SUBJECT: PERRY NUCLEAR POWER PLANT, UNIT NO. 1 - ISSUANCE OF AMENDMENT
CONCERNING CHANGES TO PRESSURE TEMPERATURE CURVES (TAC NO.
MF4351)(L-14-150)

Amendment No. 168
License No. NPF-58

SAFETY EVALUATION BY THE OFFICE OF NUCLEAR REACTOR REGULATION
RELATED TO AMENDMENT NO. 168 TO FACILITY OPERATING LICENSE NO. NPF-58

FIGURE 3.4.11-1(a): PRESSURE TEST CURVES (VALID UP TO 32 EFY)

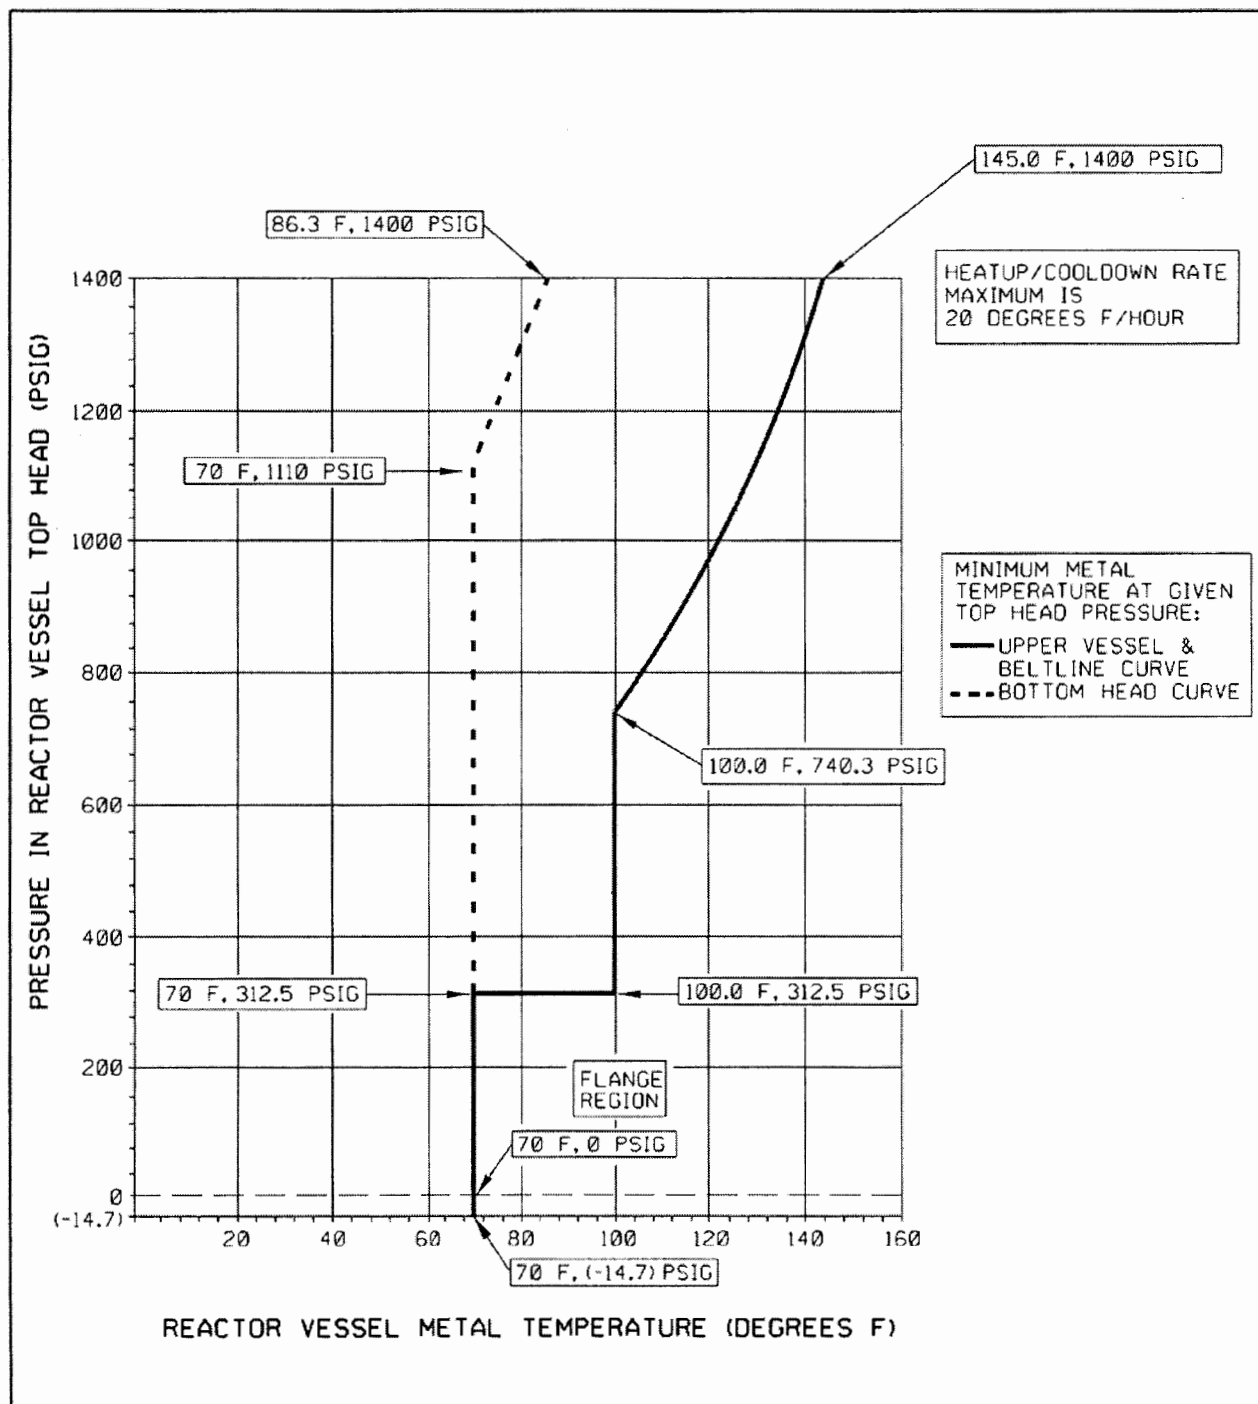
As discussed in Section 1.0 of the June 23, 2014, submittal, the licensee requests the deletion of three figures (TS Figures 3.4.11-1(a) – 3.4.11-1(c)). The NRC staff reviewed the application for the neutron fluence calculations used to support the removal of the 22 EFPY P/T limit curves expiring in June 2015, in the licensee's application for implementation into TS 3.4.11. The NRC staff determined that the version of the submitted 32 EFPY curves had been previously approved as discussed in a SE dated April 29, 2003 (ADAMS Accession No. ML030700189). The NRC staff reviewed the information provided including information from a previous submittal dated November 20, 2013 (ADAMS Accession No. ML 13330A905) for the Boiling Water Reactor Vessels Internal Program (BWRVIP) Integrated Surveillance Program (ISP). Based on that review the NRC staff determined that the current neutron fluence values remain applicable for the updated 32 EFPYs P/T limit curve, due to no identified revisions to the neutron fluence calculation since the curves were last approved by the NRC.

Based on the deletion of these figures being needed to reflect the existing design basis, that is that the PNPP will soon be beyond 22 EFPYs and therefore the curves will no longer be valid, and the existence of appropriate P/T as revised by the associated amendment to this SE, the NRC staff determined that deletion of the 22 EFPYs TS Figures 3.4.11-1(a) – 3.4.11-1(c) is acceptable. Based on the deletions of these TS Figures, the NRC staff also finds it appropriate to renumber the current TS Figures 3.4.11-1(d) – TS Figures 3.4.11-1(f) to TS Figures 3.4.11-1(a) – 3.4.11-1(c), respectively.

The NRC staff performed independent evaluations and verified that the P/T limits were developed appropriately using the approved methodologies, and the proposed P/T limits valid for 32 EFPYs satisfy the requirements of Appendix G to Section XI of the ASME Code and Appendix G to 10 CFR Part 50. Therefore, based on the proposed RPV P/T limits being sufficiently bounding for the identified materials and having used an approved methodology as documented in GE-NE-0000-0000-8763-01, Revision 0, and BWROG-TP-11-023-A, Revision 0, the NRC staff finds the revisions to the P/T curves in TS Figures 3.4.11-1(d) – 3.4.11-1(f) acceptable.

In Section 2.0 of the June 23, 2014, submittal, the licensee describes various changes to text elements of current TS Figures 3.4.11-1(d) – 3.4.11-1(f). The NRC staff reviewed the proposed revisions to the identified TS Figures and determined that the changes provide greater parity with the intent of the curves as discussed in Attachment 4 to the June 23, 2014, submittal. As the proposed changes to text elements on the TS figures reflect the technical discussions reviewed above and do not materially alter the TS requirements, the NRC staff finds the revisions to current TS Figures 3.4.11-1(d) – 3.4.11-1(f) acceptable.

FIGURE 3.4.11-1(b): NON-NUCLEAR HEATUP/COOLDOWN CURVES (VALID UP TO 32 EFY)

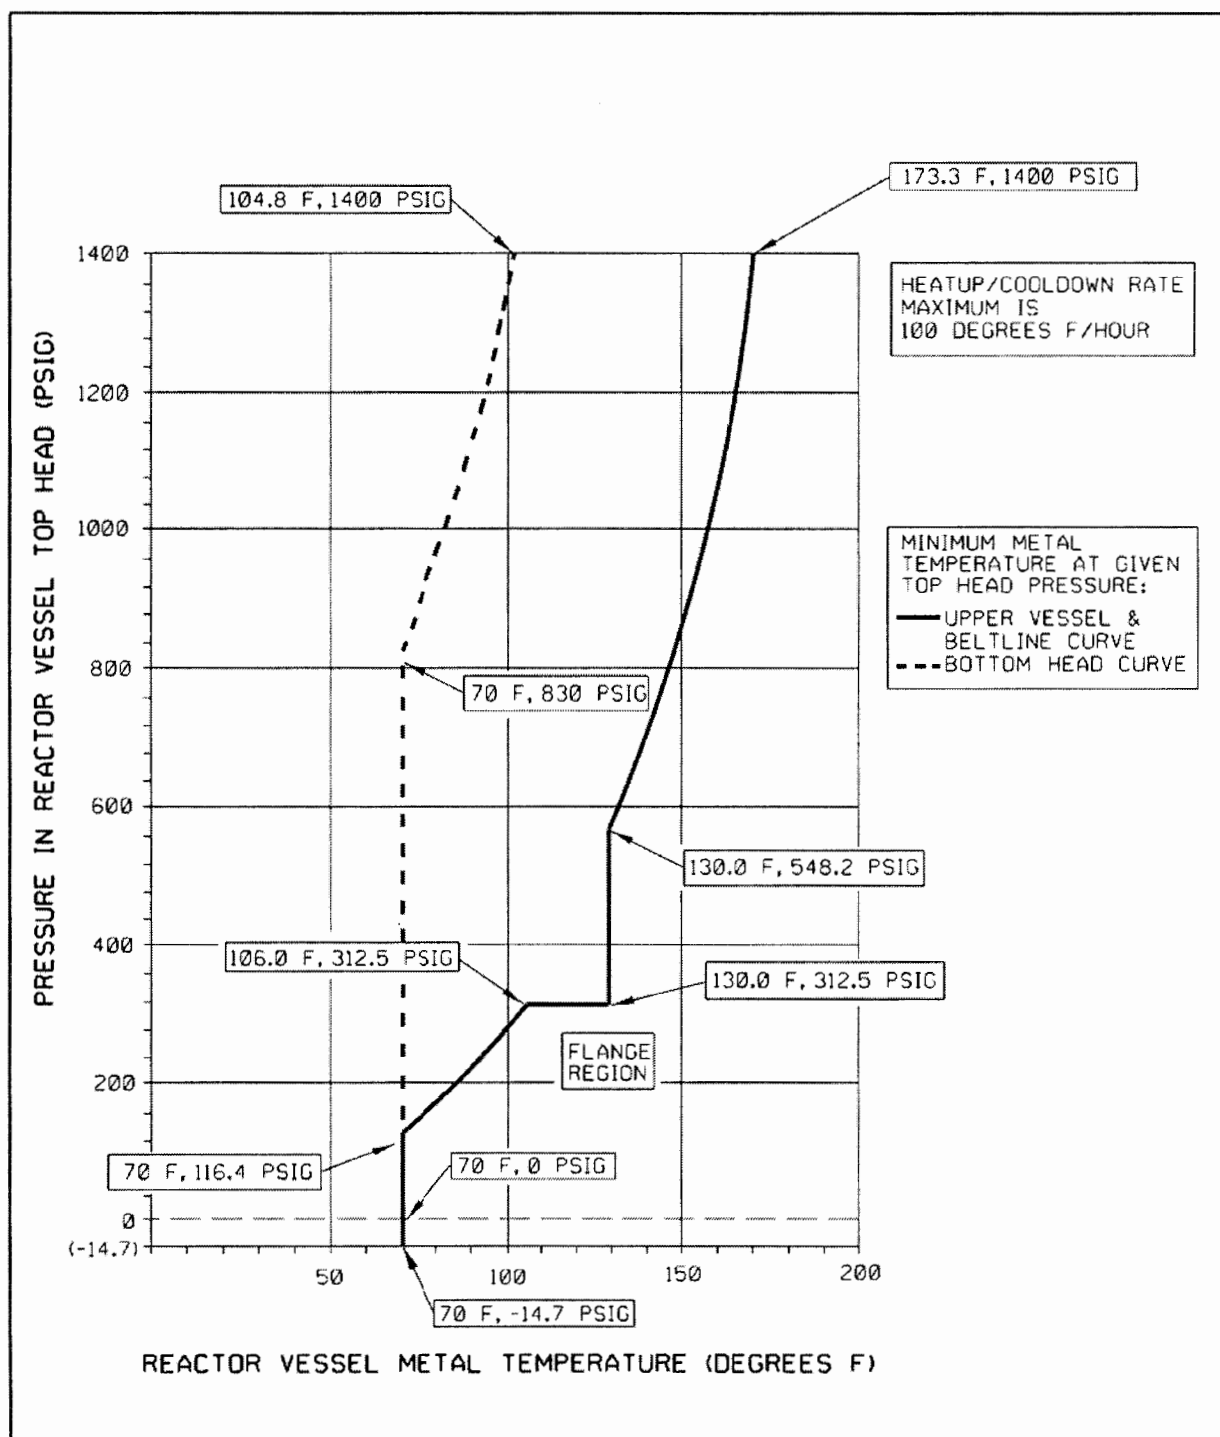
Further, in Section 2.0, the licensee describes the deletion of TS SR 3.4.11.1.b to delete the requirement to ensure that the RCS heatup and cooldown rates are less than 100 °F in any 1-hour period and add the language “within the limits of Figure 3.4.11-1.” The NRC staff reviewed the current TS Figures 3.4.11-1(d) – 3.4.11-1(f) and noted that with the exception of current TS Figure 3.4.11-1(d) the TS Figures already included a note that the heatup/cooldown rate was 100 °F/hr. Current TS Figure 3.4.11-1(d) has a note that is more restrictive (20 °F/hr) than the current SR 3.4.11.1.b. Verification that operation is within the pressure-temperature limits report is required when RCS pressure and temperature conditions are undergoing planned changes. As discussed in Section II of the attachment the 20 °F/hr limit is consistent with the hydrostatic leak test assumptions the curve is included to address. Therefore, as the proposed changes ensure consistency with the design bases for the curve and element a conflict between the less restrictive TS SR requirements and the more restrictive TS Figure, the NRC staff finds the proposed change to TS SR 3.4.11.1.b acceptable.
